PHYLLIS RUTH MILLER ELEMENTARY SCHOOL

Official Zoning Agenda

1. VW MONTESSORI SCHOOL, INC. (09-9-CZ7-1/09-032) **32-52-42**
Area 7/District 4

MIAMI-DADE COUNTY DEPARTMENT OF PLANNING AND ZONING
RECOMMENDATION TO COMMUNITY COUNCIL No. 7

SITE PLAN

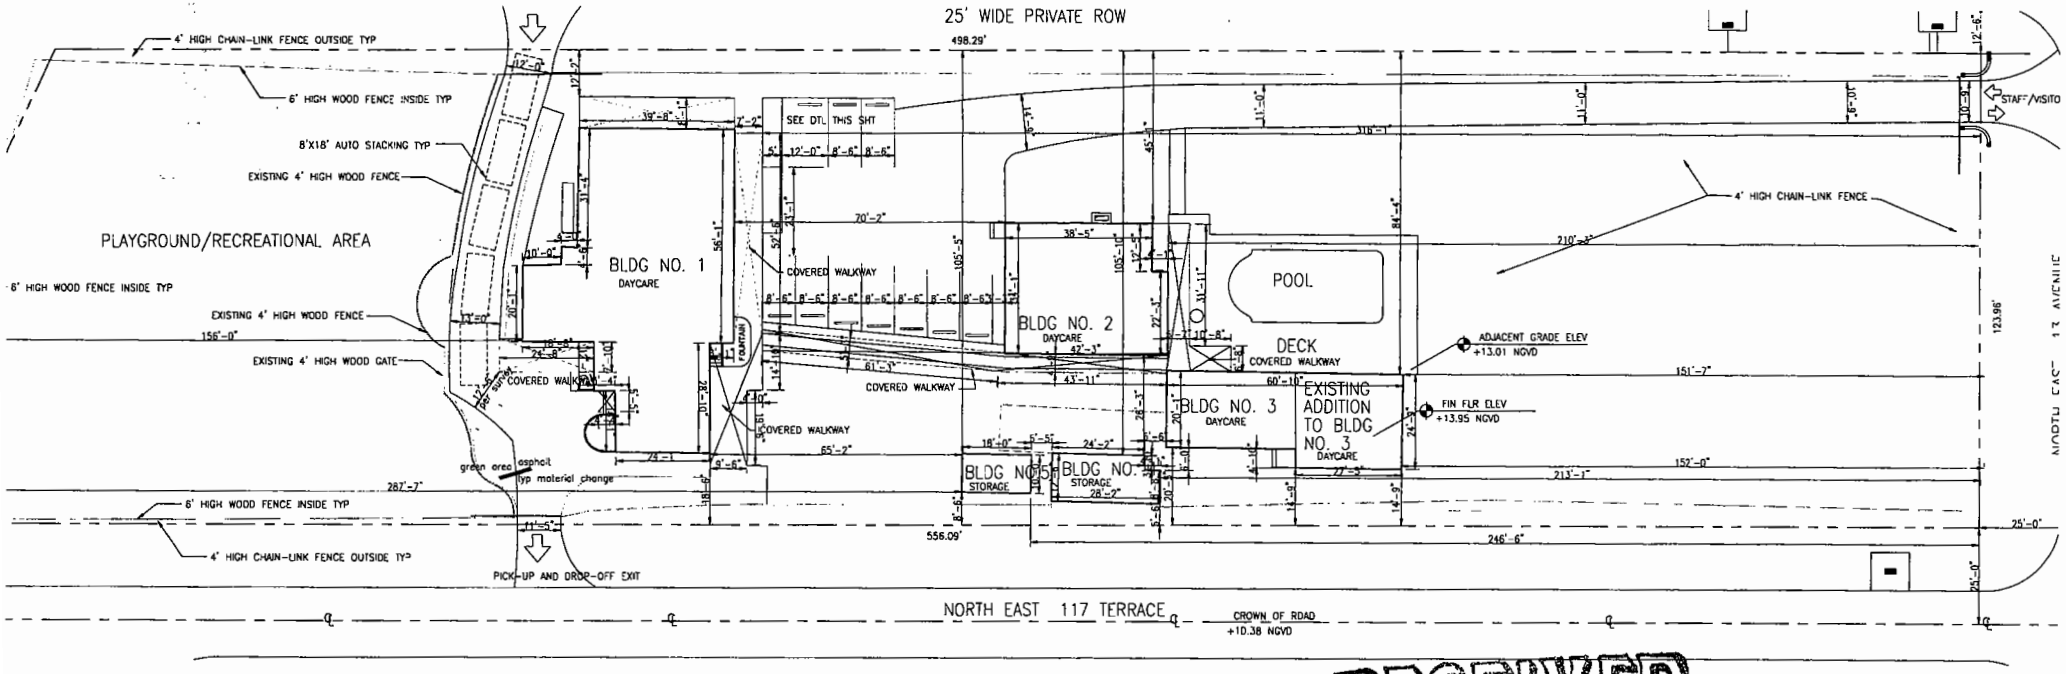
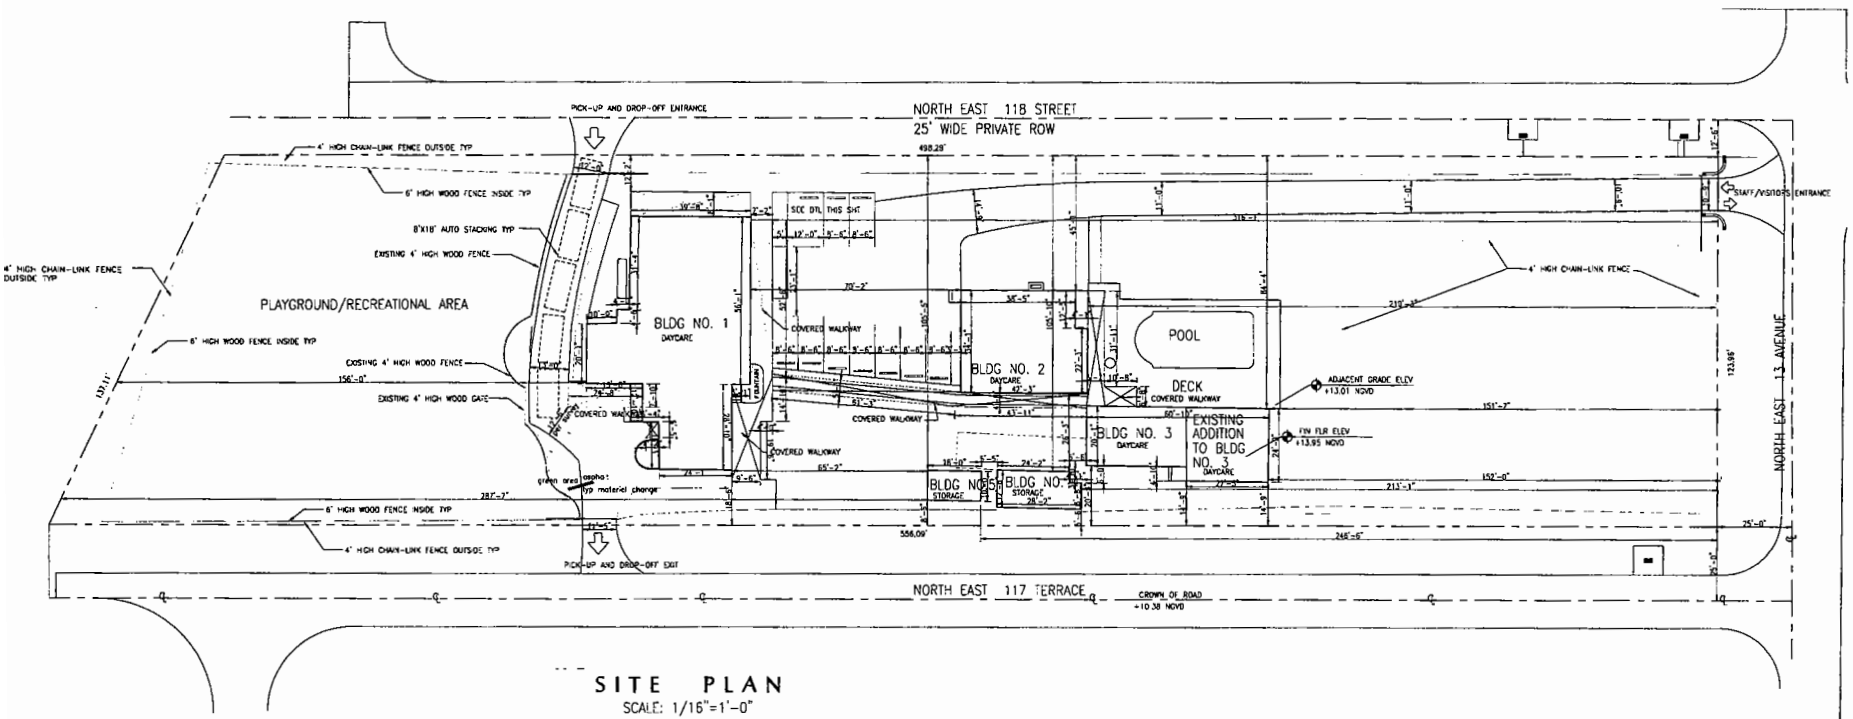
When request #3 is analyzed under Section 33-311(A)(4)(b), the Non-Use Variance (NUV) Standards, staff is of the opinion that the approval of this request would be **incompatible** with the surrounding area, would negatively affect the stability and appearance of the community and would be a detriment to same. Staff notes that the subject property has adequate space to provide the required twenty (20') foot two-way driveway and the required fourteen (14) foot one-way driveway. However, the plans submitted by the applicant depict the continued use of an existing 10'9" two-way driveway and 11'6" one-way driveway which, in staff's opinion, do not provide adequate space for vehicles to ingress and egress the school facility during the drop off and pick up times. As such, staff recommends denial without prejudice of this request under Section 33-311(A)(4)(b) of the NUV standards.

This memo supersedes MDFR memorandum dated July 30, 2009.
OBJECTIONS:
These objection are for site plan date stamped May 26, 2009.
- One-Way shall be 15 feet minimum width.

Current service impact calculated based on site plan date stamped My 26, 2009. Substantial changes to the plan will require additional service impact analysis.

4. That in the approval of the plan, the same be substantially in accordance with that submitted for the hearing entitled 'Von Wedel Montessori School, Inc.,' as prepared by Orestes Lopez-Recio, Architect, dated stamped received 5/26/09 and consisting of 7 sheets." Except as herein modified to show the required 20' two-way and 14' one-way driveway widths.

LANDSCAPING PLAN

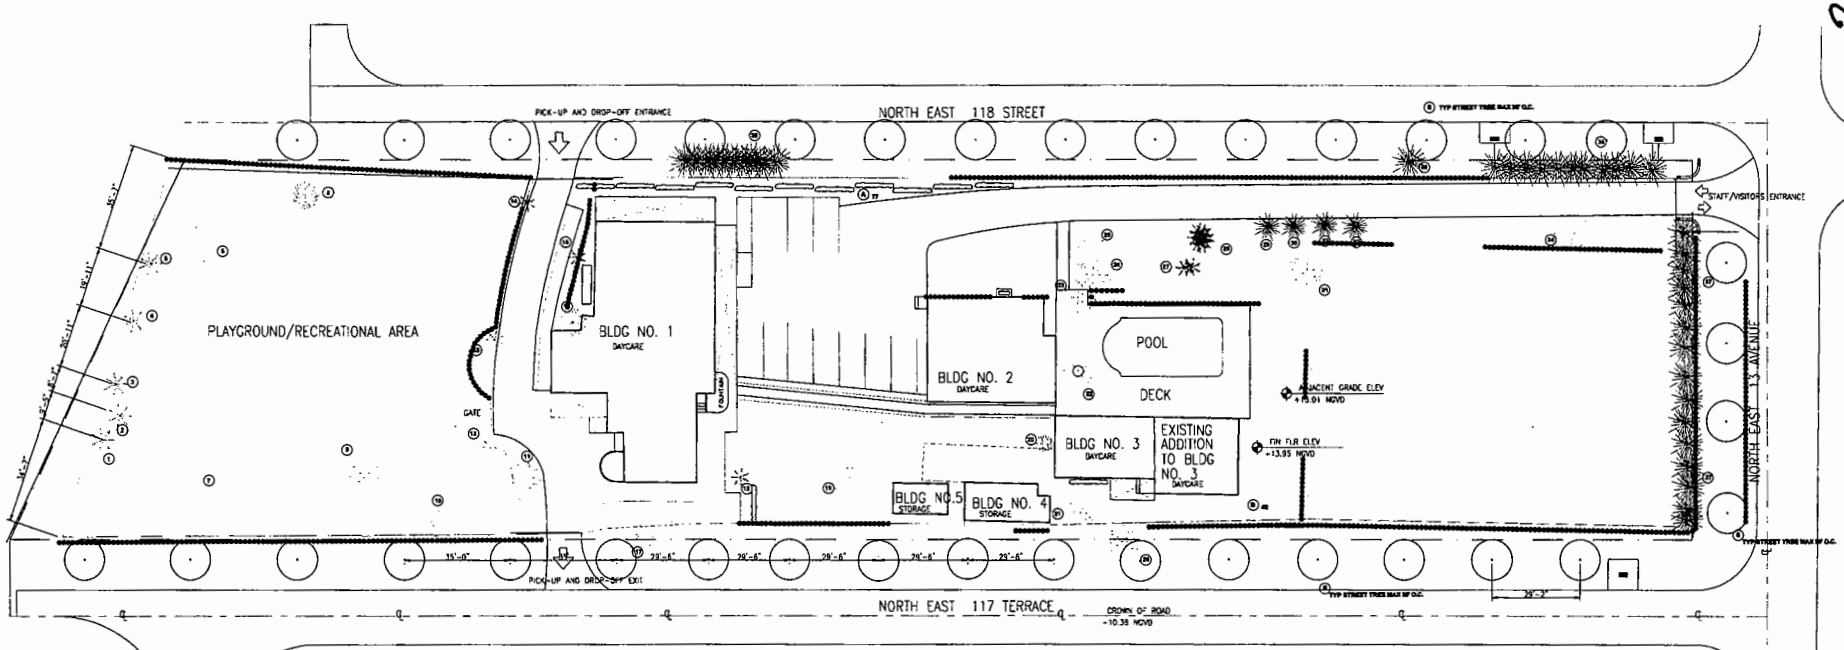
Tree Preservation
According to the site and landscape plans submitted with this zoning application, the proposal to permit existing buildings and a variance for the driveway width will not impact tree resources. Therefore, the Tree Program has no objection to this zoning application, however please be advised that the property contains specimen-sized (trunk diameter 18 inches or greater) trees. Section 24-49.2(II) of Chapter 24, the Code of Miami-Dade County requires that specimen trees be preserved whenever reasonably possible. A Miami-Dade County Tree Removal Permit is required prior to the removal or relocation of any tree that is subject to the Tree Preservation and Protection provisions of Chapter 24. Said Tree Removal Permit shall meet the requirements of Sections 24-49.2 and 24-49.4 of the Code.

3. That prior to issuance of a building permit, the applicant submit to the Department of Planning and Zoning for its review and approval a landscaping plan which indicates the type and size of plant material. Said landscaping shall be installed prior to final zoning inspection.
